<b>Title:</b> Numa Bridge Replacement – Kootenay National Park		
<b>Solicitation No. / N° de l'invitation :</b> 5P420-17-5438/A	<b>Amendment No. / N° de modification de l'invitation :</b> 004	<b>Date:</b> March 5, 2018  <b>Date :</b> 5 mars 2018
<b>GETS Reference No. / N° de référence de SEAG :</b> PW-18-00812968		
<b>Solicitation Closes / L'invitation prend fin :</b>		
<b>At:</b> 02:00 PM	<b>On:</b> March 13, 2018	<b>Time Zone:</b> Mountain Standard Time (MST)
<b>À :</b> 14h00	<b>Le :</b> 13 mars 2018	<b>Fuseau horaire :</b> Heure Normale des Montagne (HNM)
<b>Address Inquiries to / Adresser toute demande de renseignements à :</b> Danny Ahn		
<b>Telephone No. / N° de téléphone :</b> (403) 292-5451	<b>Fax No. / N° de télécopieur :</b> 1-866-246-6893	<b>Email Address / Courriel :</b> Danny.ahn@pc.gc.ca
<b>TO BE COMPLETED BY THE BIDDER (type or print) À ÊTRE COMPLÉTER PAR LE SOUMISSIONNAIRE (taper ou écrire en caractères d'imprimerie)</b>

## Amendment 04

This amendment is being raised to publish Q&A and extend the bid closing date.

## 3 Rail Post & Rail Fence

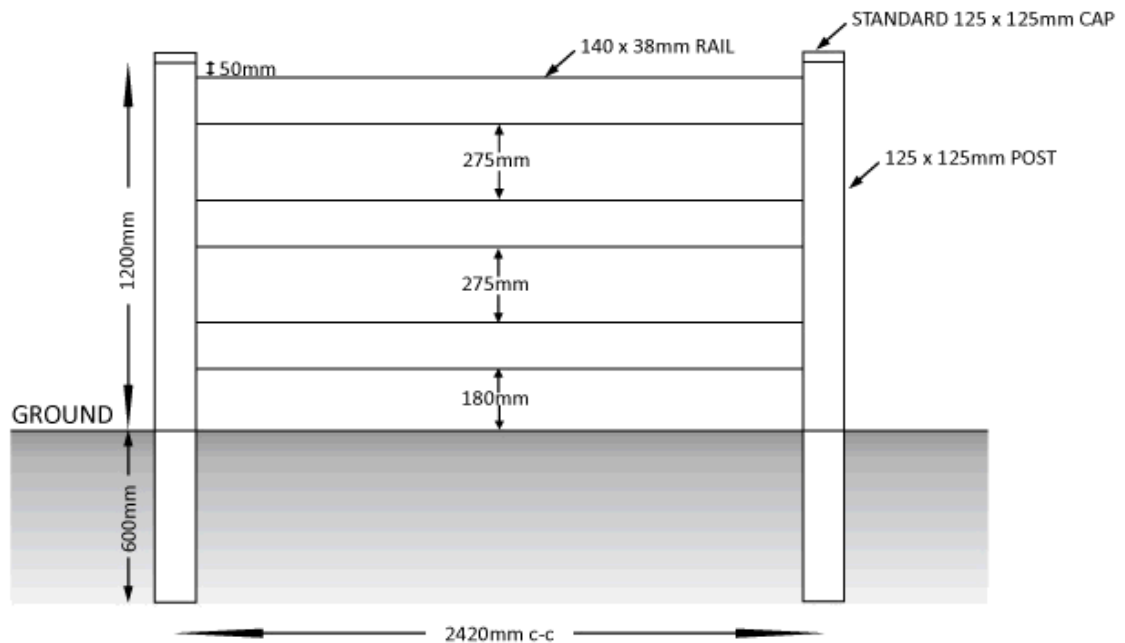
- Q5. Can details be provided for components within the parking lot and visitor amenity area such as; picnic tables, pedestrian bollards, new restroom, wooden fence, and information sign?

Fences – See next page.
